PURCHASE ORDER

ITEM #	DESCRIPTION	QTY	UNIT PRICE	TOTAL
	see quote# AWK1050010, 16June2015			
	***** Century Tywood to confirm manufacturability of threaded insert location noted on attached "change notes to revC and revD" prior to production *****			
AWK-105-0010, Housing and Cover	unfinished sheet metal parts for fit check	5	\$71.80	\$359.00
AWK-105-0010, Housing and Cover	powder coated and screen printed sheet metal housing. *planned powder coat colors are ANSI61 Gray and FED STD 34094 Green. final color and split TBD	550	\$16.60	\$9,130.00
	Screen print set up charge	1	\$225.00	\$225.00
	Lance tooling charge	1	\$485.00	\$485.00

Change notes since last quote (now at Rev D.)

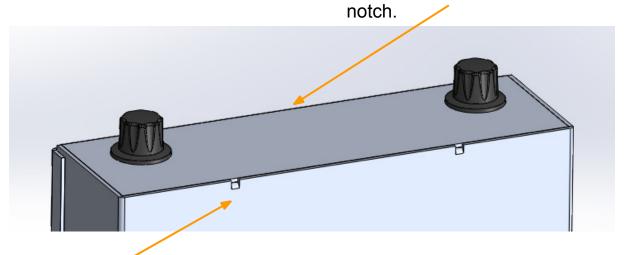
- 1. Material thickness changed from .060" to .050"
- 2. Overall dimensions slightly smaller
- 3. Addition of notches (see below)
- 4. QTY will be 550 pcs, each.
- 5. I am talking to Roy about finish. We'll run two different colors, ANSI 61 Gray with black screenprint, and FED STD 34094 Green, with white screenprint. Final batch sizes TBD.
- 6. Artwork for screenprints is attached

- 7. Height of box changed from 4" to 3.5"
- 8. Holes for knobs in top opened up
- 9. Only powder coat exterior faces
- 10. Artwork updated for new box size

can this edge be overbent slightly to improve fit? the face will then squeeze the

notch is intended to support case wall.

can the notch be formed on the turret punch?
